## **CORRIGENDUM - 1**

# **Ref: - NIT No. -12531/CREDA/SPV-PUMPS/SSY-IV/2019 Dated: 23-10-2019**

(RFX ID No. - 8100015942)

#### **ANNEXURE - I**

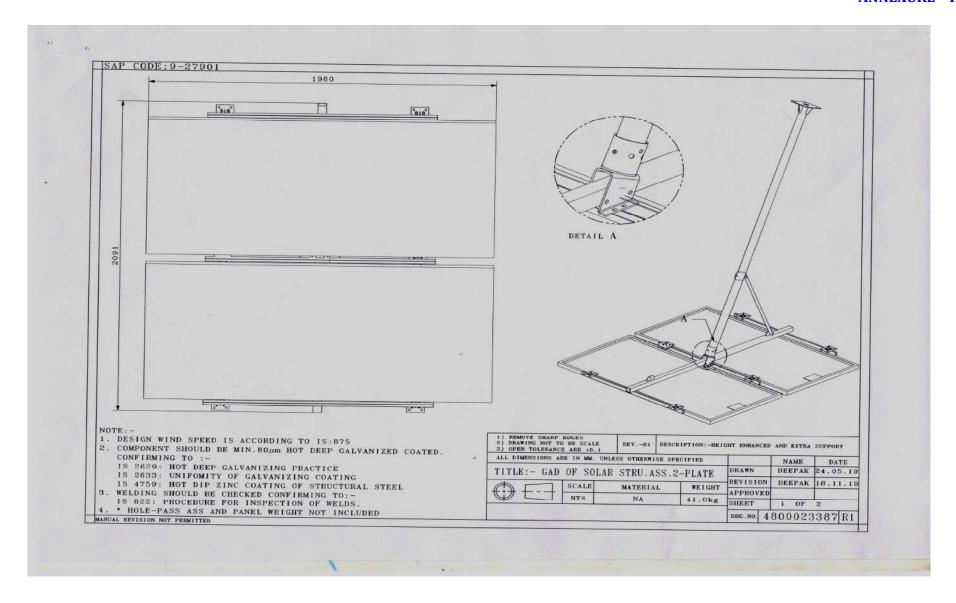
02	Page no 27 & 47-50 / Clause no. 3 , Point no E and Annexure-VI	MMS should adhere to the drawings produce in the Annexure VI	All drawings of MMS are amended as per Annexure-II (attached in this corrigendum)
